International Nuclear Event Scale (INES) Meeting

June 25, 2003

Alan Nelson - NEI

Defense in Depth Criteria

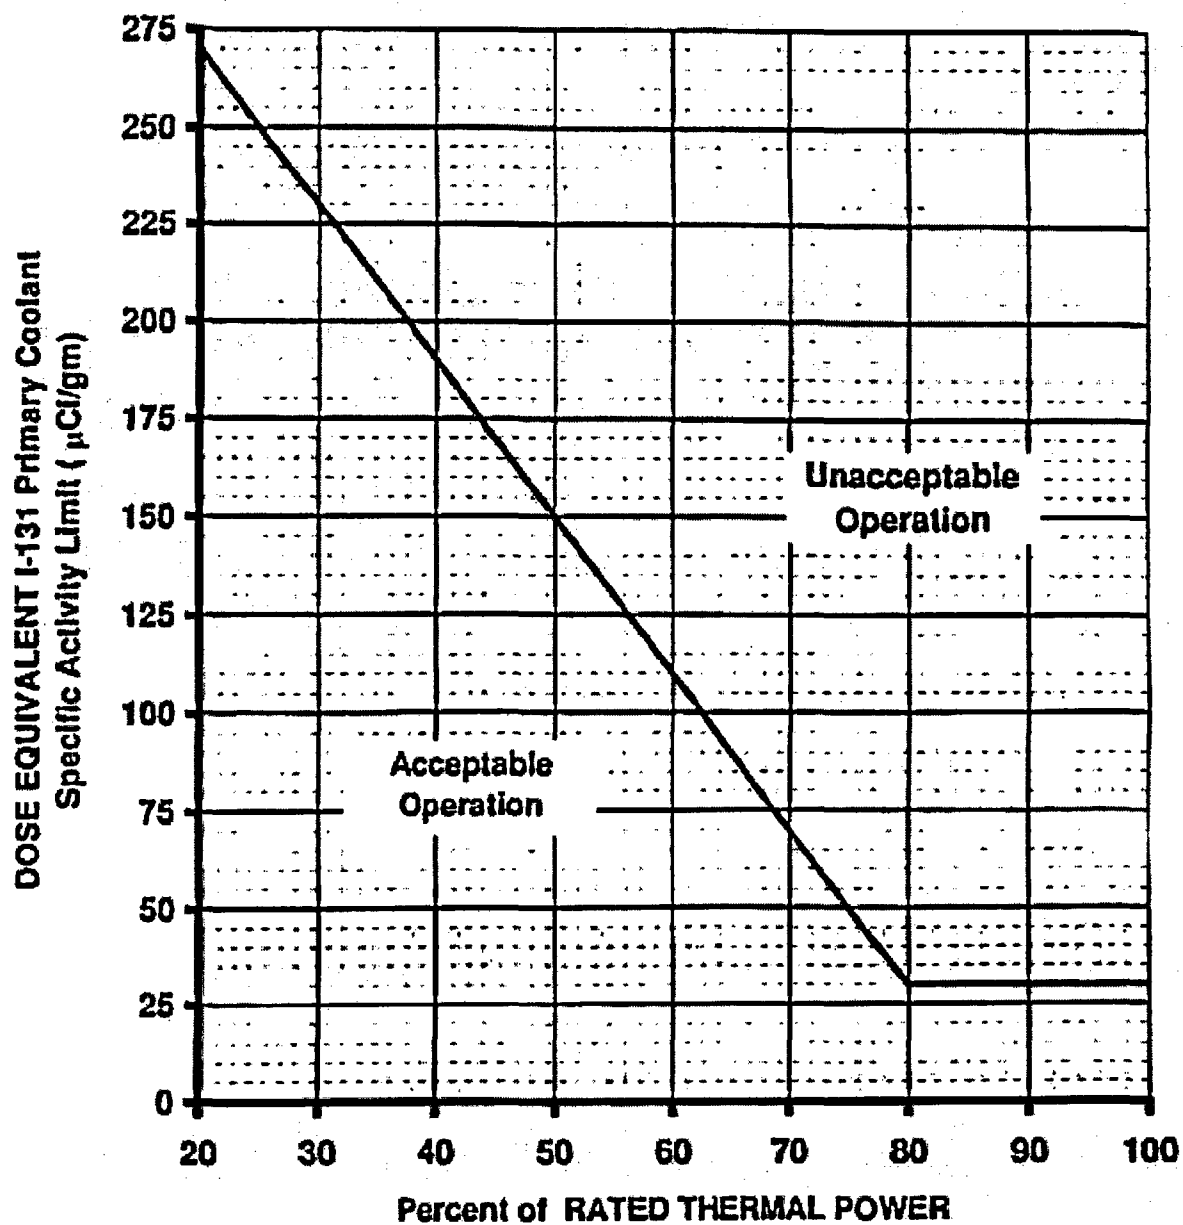
- Has multiple examples provided for the user but excludes examples dealing with RCS activity and clad damage
- Recommend RCS activity examples be added for clarification

- Level 2
 - ◆ DEI elevated into the Unacceptable Operation region of the Technical Specification transient limit requiring shutdown
- Level 1
 - ◆ DEI elevated into the Allowable Operation region of the Technical Specification transient limit for greater than the specified action statement time limit requiring shutdown
- Level 0
 - ◆ DEI elevated out of normal Technical Specification operating limit but returned to within normal operating limit within specified action statement time limit with no shutdown required
